AL SHURHABIL SCHOOL
UNDER THE COMMANDER'S EMERGENCY RESPONSE PROGRAM
ANBAR PROVINCE, IRAQ

SUSTAINMENT ASSESSMENT

SIGIR PA-08-142
JANUARY 21, 2009

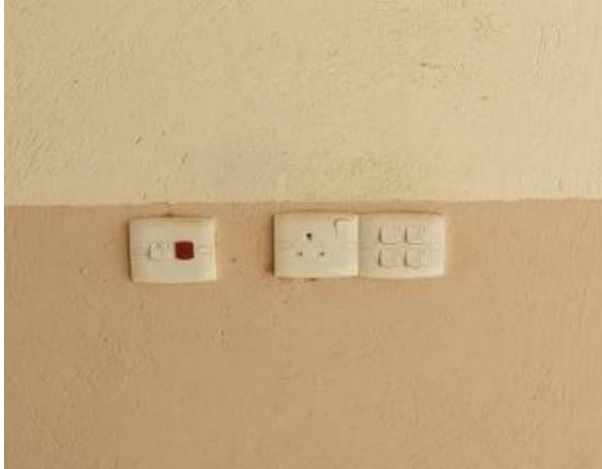
During the site visit, SIGIR observed the construction of the new classroom buildings. The roof tiles appeared to be in good condition throughout the expanse of the roof (Site Photo 8). There were drainage holes at the roof's edges, which will allow water to drain from the roof. The exterior and interior walls appeared to be adequately repaired/replaced (Site Photos 9 and 10). The majority of the interior tile and concrete floor work was good; however, there were areas of missing and broken tiles, as well as, uneven floors (Site Photo 11).
